NYMNP

From: Mick Paxton
Sent: 05 December 2018 09:57
To: Harriet Frank
Subject: Re: NYM/2018/0564/FL

AMENDED

proposed layout and elevations

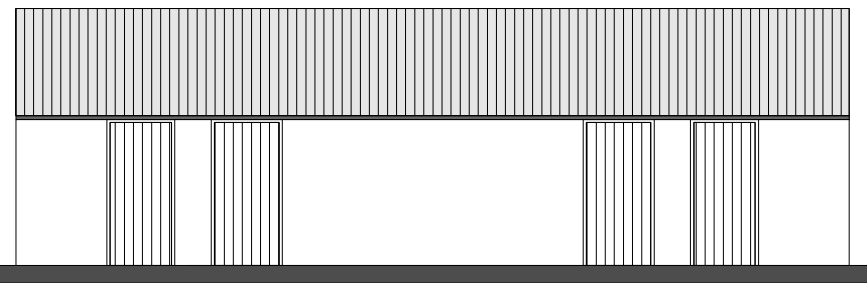
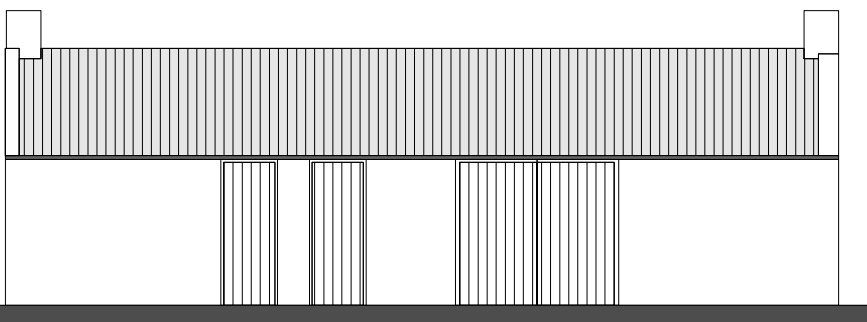
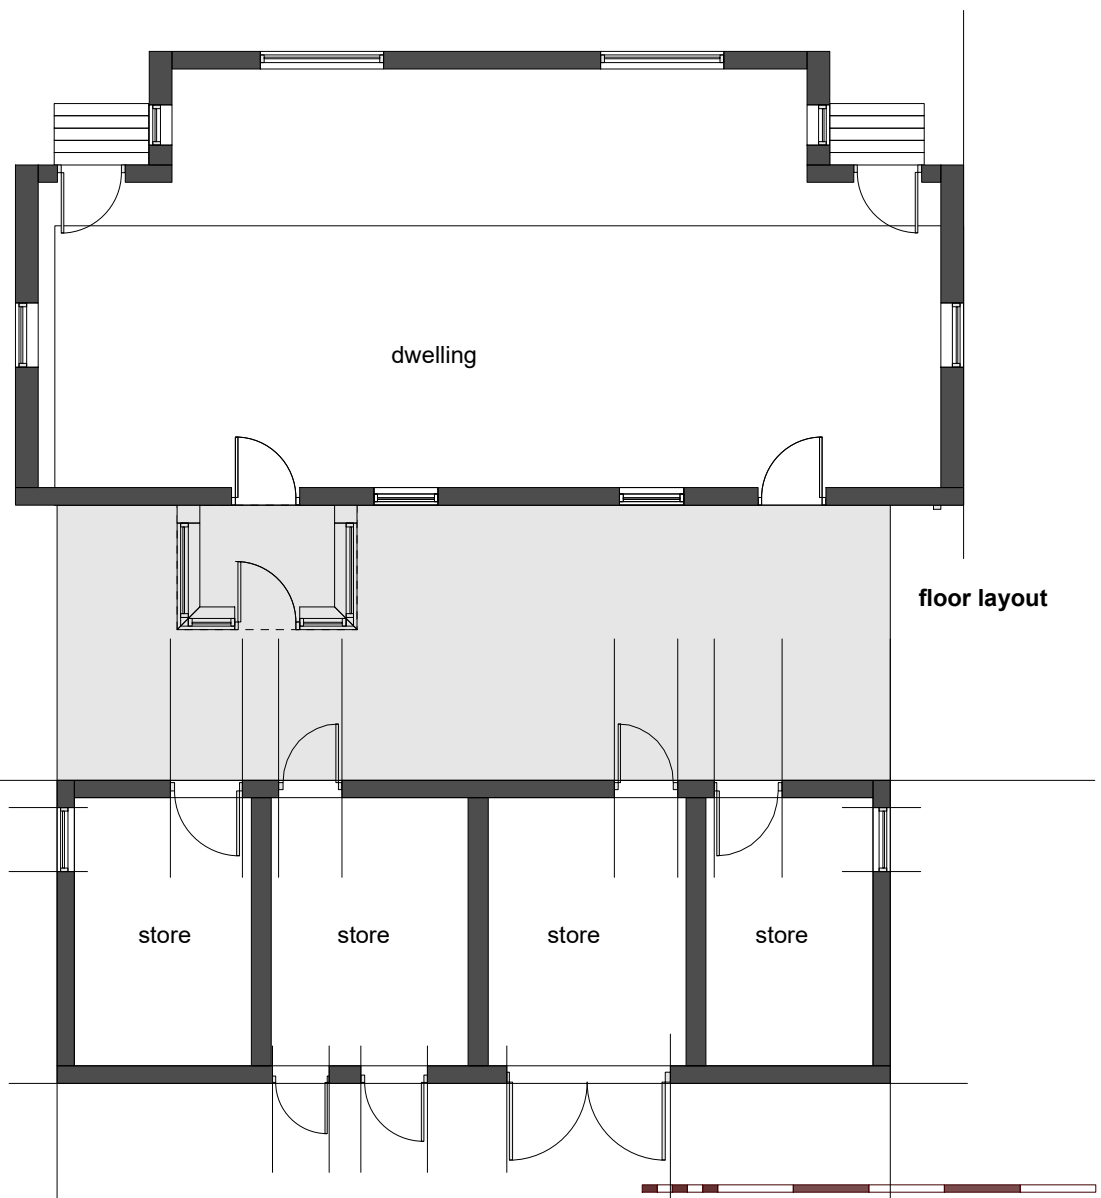
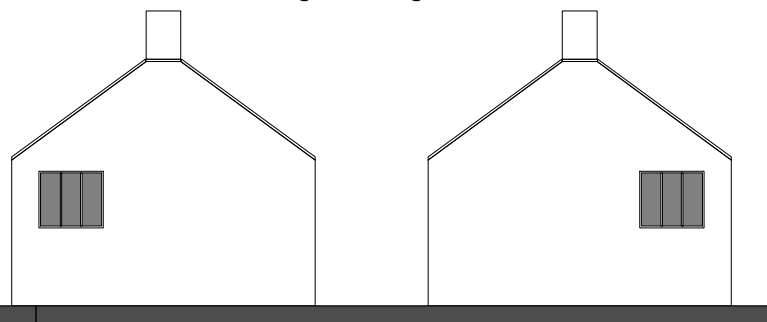
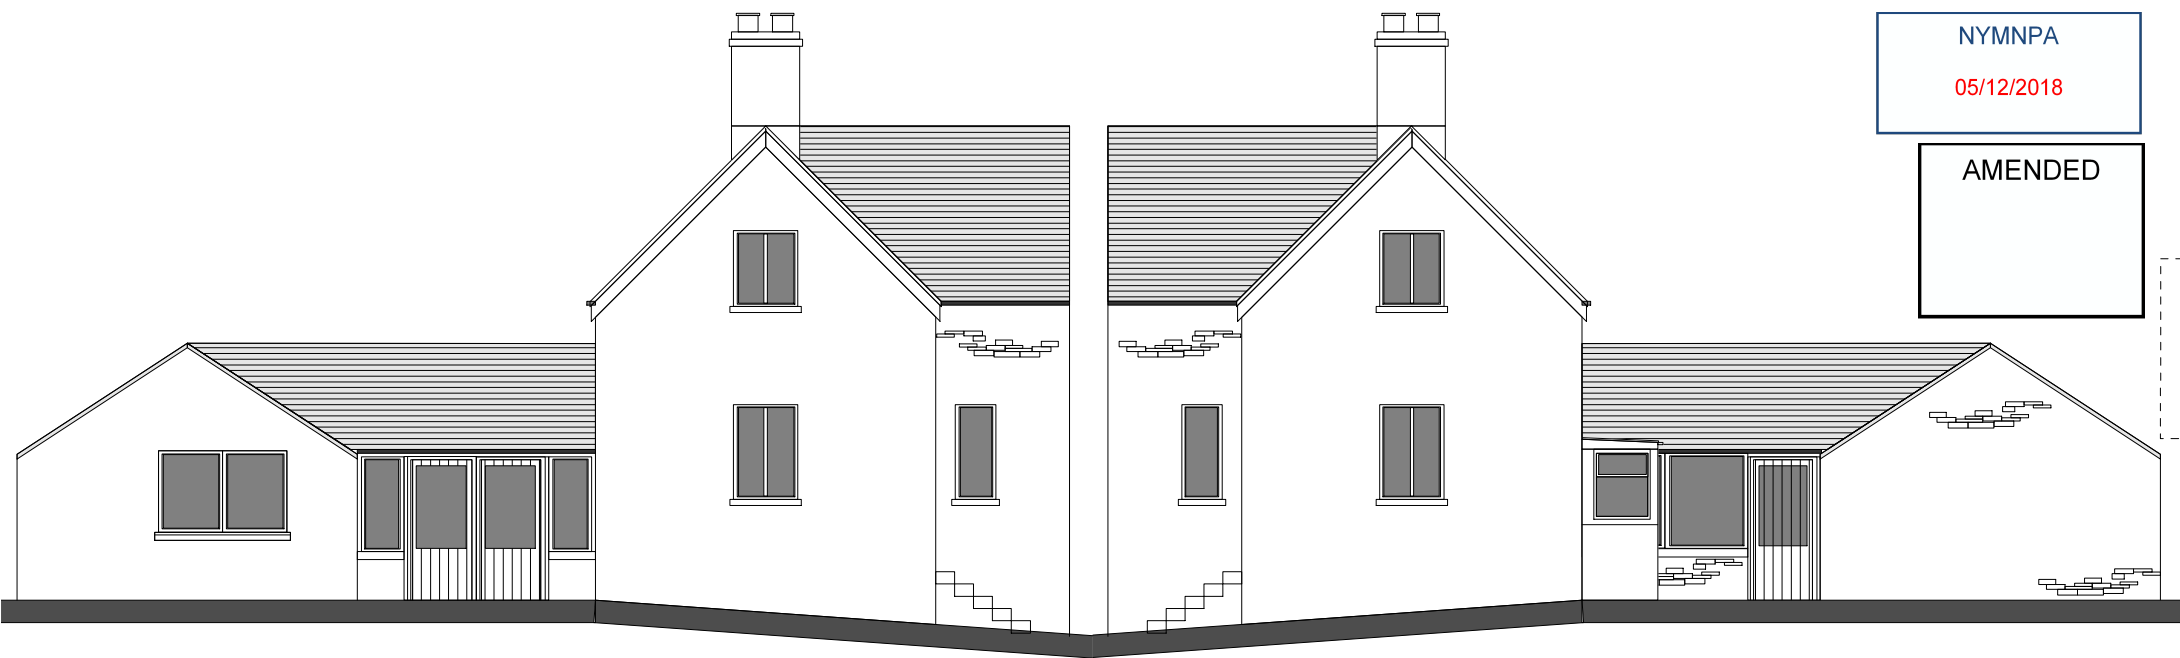
hi harriet - these are the drawings and peter would like to keep the existing porch - it gives them good protection to the rear door - would that be ok?
do you need an extension of time for this? - regards mick
